Site Accessibility Evaluation

Homestead Ranch Regional Park

Accessibility Evaluation

Inspection Date: 01/30/2018

Finding 99591 Main Photo

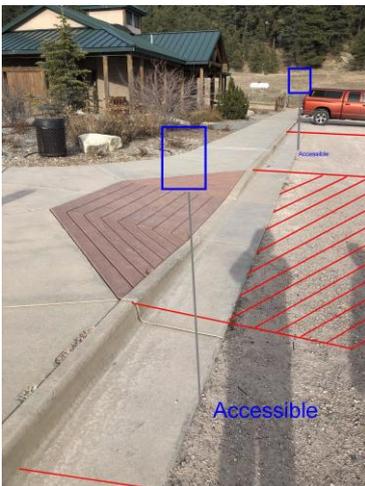
Finding: 1

There are no accessible parking stalls.

No accessible aisles
nor accessible stalls.

Based on 9 ft - width parking stall measurements it was determined that there are 50 stalls available, which would require two accessible parking stalls. Recommend making both Van accessible w/proper international symbol of accessibility signage. This means that the area that needs to be paved would include two accessible parking stalls with accessible aisle leading directly to pedestrian ramp.

Finding 100876 Main Photo

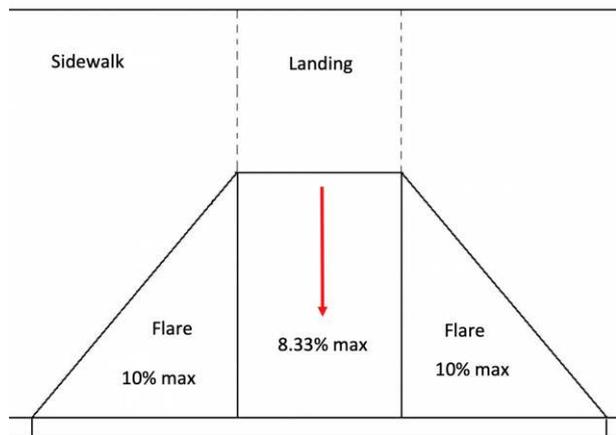
The curb ramp slope exceeds the maximum running slope (direction of travel) allowable of 8.33%.

Curb ramp slope is
10.07%

Curb ramp must be reconstructed to meet the maximum running slope allowed of 8.33%.

Finding 100878 Main Photo

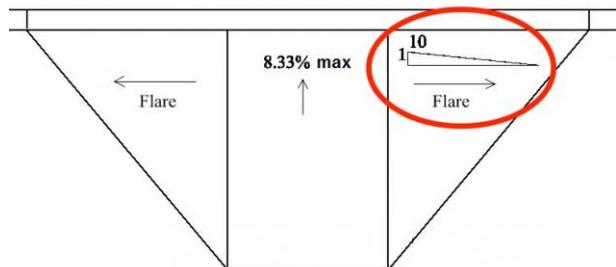
The curb ramp side flares are too steep.

Ramp flares exceed the maximum allowed. Left 12.19% and Right 11.13%

Reconstruct flares/ramp to meet the maximum 1:10 slope.

Finding 103411 Main Photo

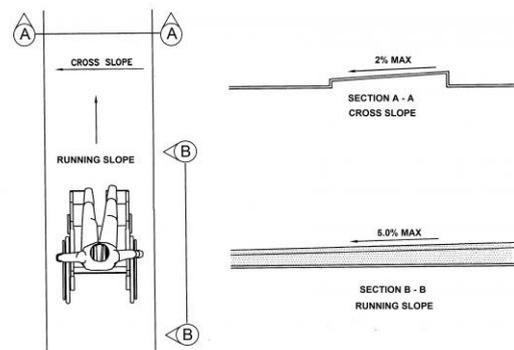
The accessible route contains running slopes greater than 5 percent and cross slopes greater than 2 percent across the width of the walk and has not been constructed as a ramp (i.e. handrails, wheel guides, etc.).

Some sections of the route exceed the maximum running and cross slope allowed.

Replace and/or adjust each section to meet ADA requirements.

Finding 100797 Main Photo

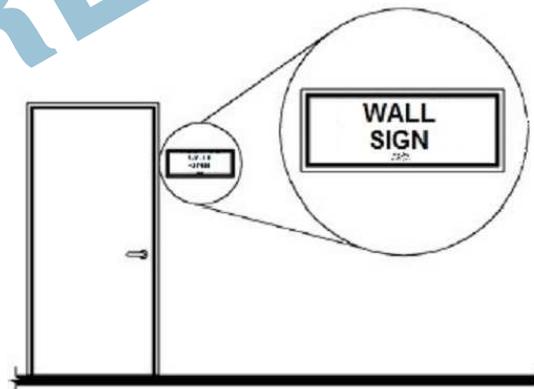
The tactile sign is incorrectly installed behind acrylic polymer.

Sign installed behind acrylic polymer

Remove acrylic polymer.

Corrective Action: work order # 420302 submitted on 1/31/18.

Finding 100806 Main Photo

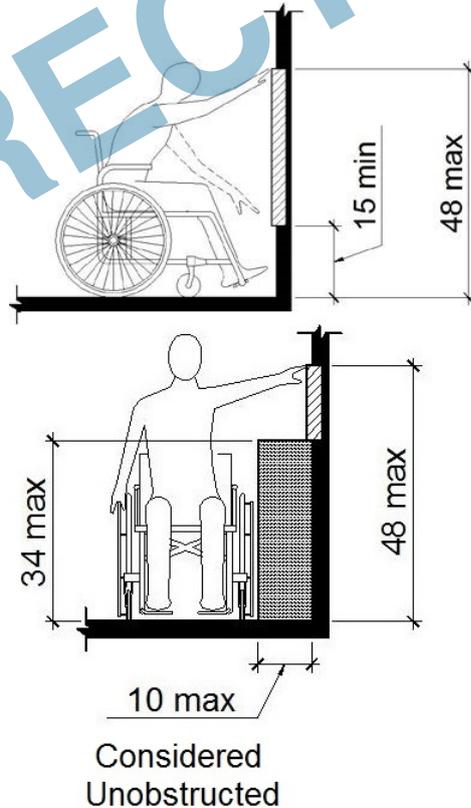
The coat hook is installed greater than 48 inches above the finished floor.

Coat hook is installed at 60 inches above finished floor.

Remove and relocate coat hook at 48 inches maximum above finished floor or install a second coat hook between 15 and 48 inches.

Corrective Action: work order # 420303 submitted on 1/31/18.

Finding 100809 Main Photo

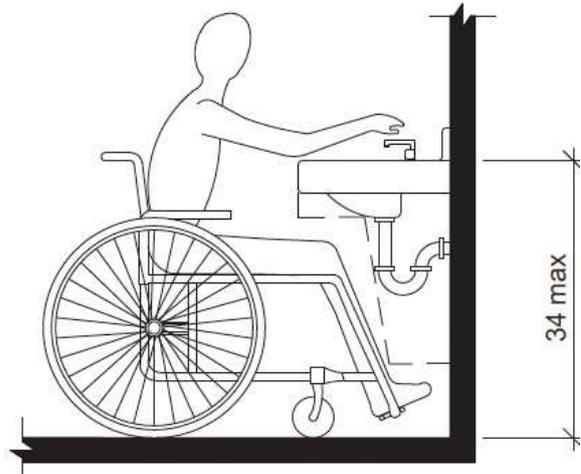
The top rim of the lavatory is too high.

Lavatory installed at 35 inches.

Lower to 2010 ADAS of 34 inches maximum above finished floor.

Corrective Action: work order # 420305 submitted on 1/31/18.

Finding 100815 Main Photo

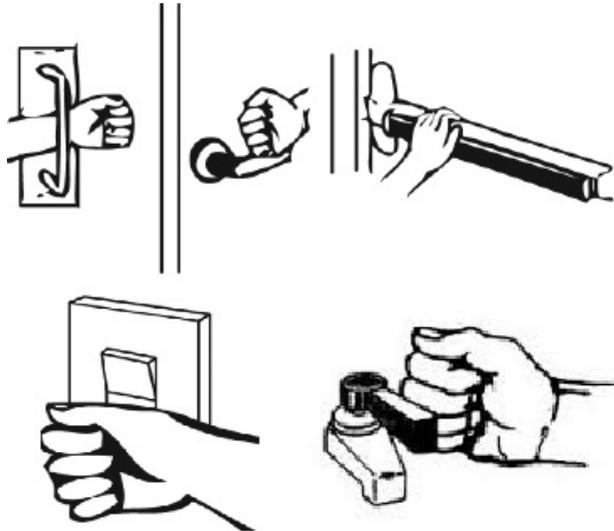
The force required to operate the element exceeds the maximum.

Flush control force to operate is set at 10 lbs.

Adjust flush control force to activate to 5 lbs maximum force.

Corrective Action: work order # 420304 submitted on 1/31/18.

Finding 100817 Main Photo

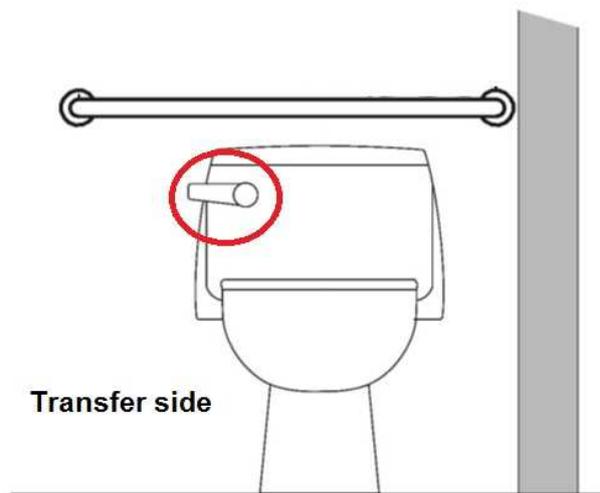
The flush handle is located on the wrong side of the toilet.

Flush control not located on open side of water closet.

Install flush control on open side of water closet no more than 44 inches above finished floor.

Corrective Action: work order # 420301 submitted on 1/31/18.

Finding 100819 Main Photo

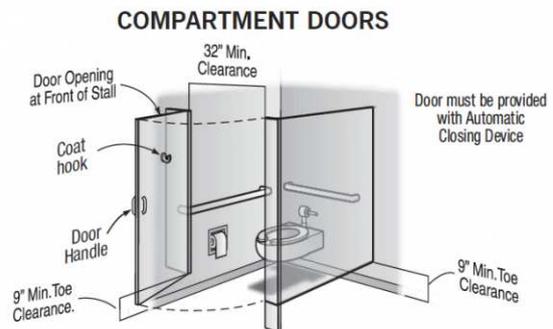
The compartment door is not self closing.

Not self closing.

Install an automatic self closing device to toilet compartment door.

Corrective Action: work order # 420355 submitted on 1/31/2018

Finding 100823 Main Photo

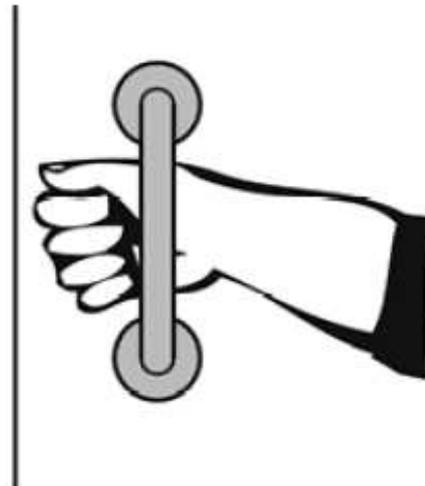
The water closet compartment door is missing a loop handle on the inside.

No loop handle installed.

Install loop handle on inside of toilet compartment door.

Corrective Action: work order # 420354 submitted on 1/31/2018

Finding 100807 Main Photo

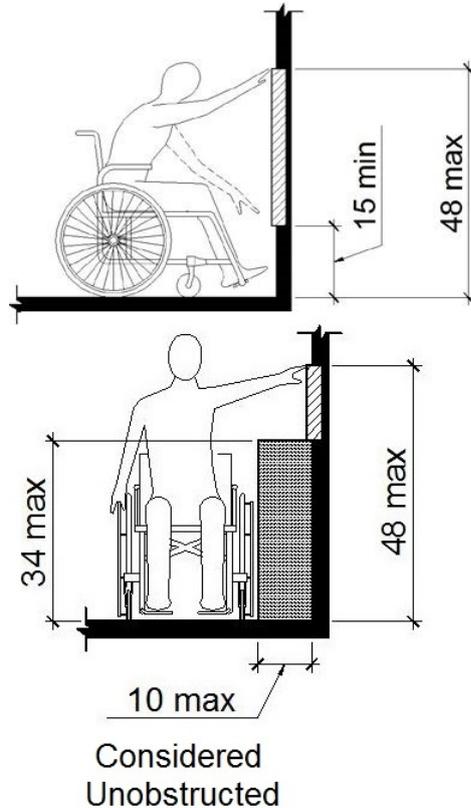
The coat hook is installed greater than 48 inches above the finished floor.

Coat hook is installed at 60 inches above finished floor.

Remove and relocate coat hook at 48 inches maximum above finished floor or install a second coat hook between 15 and 48 inches.

Corrective Action: work order # 420353 submitted on 1/31/2018

Finding 100810 Main Photo

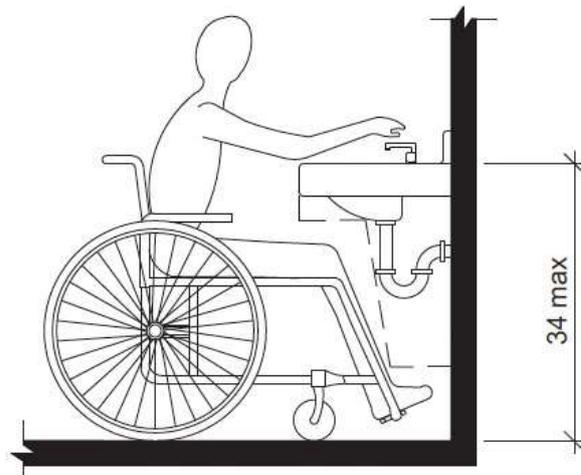
The top rim of the lavatory is too high.

Lavatory installed at 35 inches.

Lower to 2010 ADAS of 34 inches maximum above finished floor.

Corrective Action: work order # 420352 submitted on 1/31/2018

Finding 100816 Main Photo

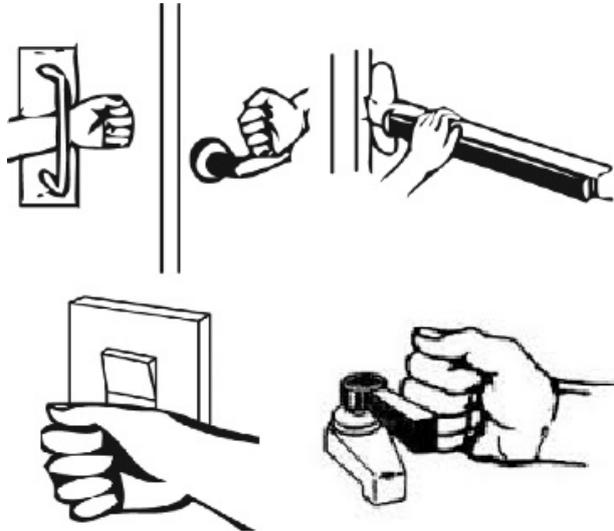
The force required to operate the element exceeds the maximum.

Flush control force to operate is set at 17 lbs.

Adjust flush control force to activate to 5 lbs maximum force.

Corrective Action: work order # 420351 submitted on 1/31/2018

Finding 100818 Main Photo

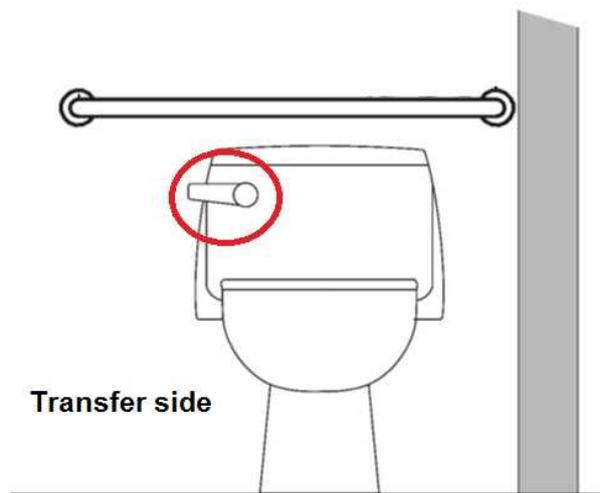
The flush handle is located on the wrong side of the toilet.

Flush control not located on open side of water closet.

Install flush control on open side of water closet no more than 44 inches above finished floor.

Corrective Action: work order # 420331 submitted on 1/31/2018

Finding 100820 Main Photo

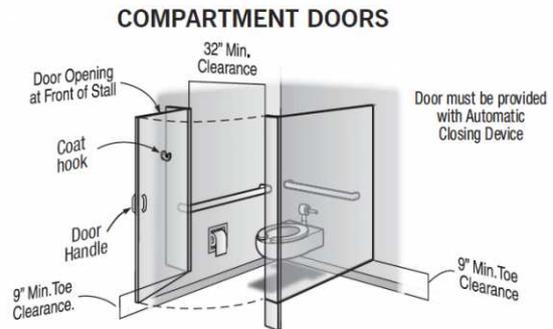
The compartment door is not self closing.

Not self closing.

Install an automatic self closing device to toilet compartment door.

Corrective Action: work order # 420330 submitted on 1/31/2018

Finding 100824 Main Photo

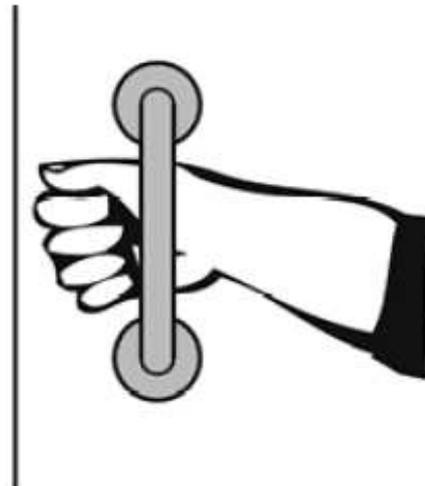
The water closet compartment door is missing a loop handle on the inside.

No loop handle installed.

Install loop handle on inside of toilet compartment door.

Corrective Action: work order # 420329 submitted on 1/31/2018

Finding 111564 Main Photo

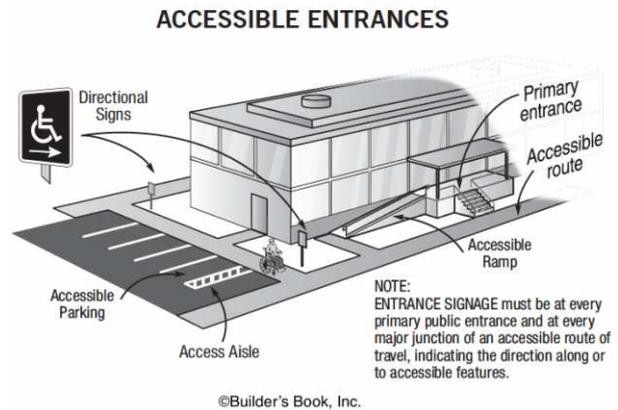
There is no accessible route to the play area.

No accessible route.

Install accessible ramp to play area.

Finding 106784 Main Photo

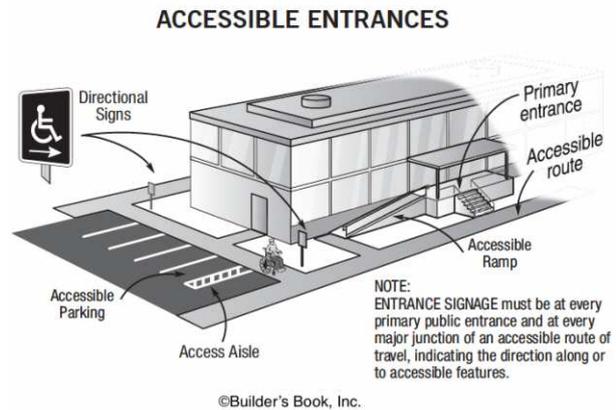
There is no accessible route to the play area.

No accessible route.

Install accessible ramp to play area.
